# **Planning and regulatory committee**

**Wednesday 17 November 2021**

**Schedule of Updates**

## **Schedule of Committee Updates/Additional Representations**

**Extract of drawing showing 18 Union Street (Koda Architects – drawing no. 1694 402 C)**

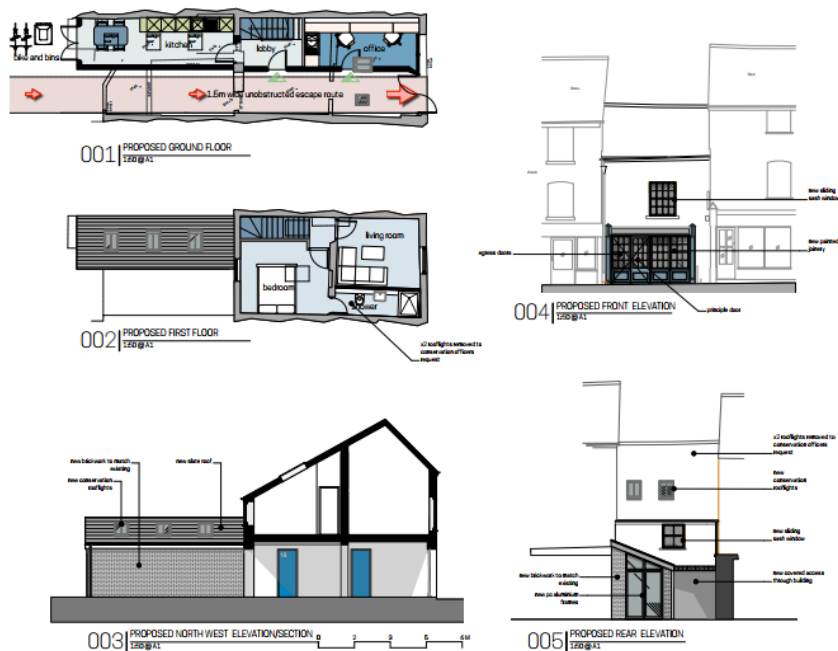
Firstly, Paragraph 1.14 of the Committee Report includes an extract of the plans in respect of the proposals at 18 Union Street. In response to comments made by the Building Conservation Officer, the applicant omitted two of the rooflights. An extract of the updated plan showing only two rooflights to the rear elevation of the building is included below.
